SUBJECT: ADDENDUM #6 TO THE BIDDING DOCUMENTS FOR:
BID GROUP #8
MASTER FACILITY PLAN IMPLEMENTATION
COMMUNITY HIGH SCHOOL DISTRICT 99
1436 NORFOLK STREET
DOWNERS GROVE, IL 60516

Project Name: District 99 MFP Implementation DG South Phase C

Bid Question/Answer Log No. 4

AUDITORIUM AND FLY GALLERY ROOF LEVEL FRAMING PLAN - AREA F

4 FRAMING DETAIL
SCALE: 3/4" = 1'-0"

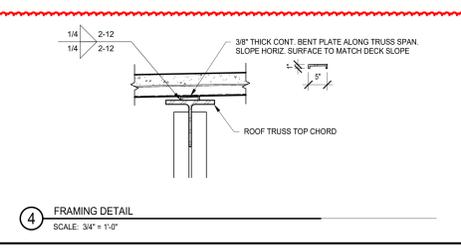
1. Sheet S2.5C-F AUDITORIUM AND FLY GALLERY ROOF LEVEL FRAMING PLAN -AREA F (**Full size sheet issued**)
 - a. Detail 4 added.
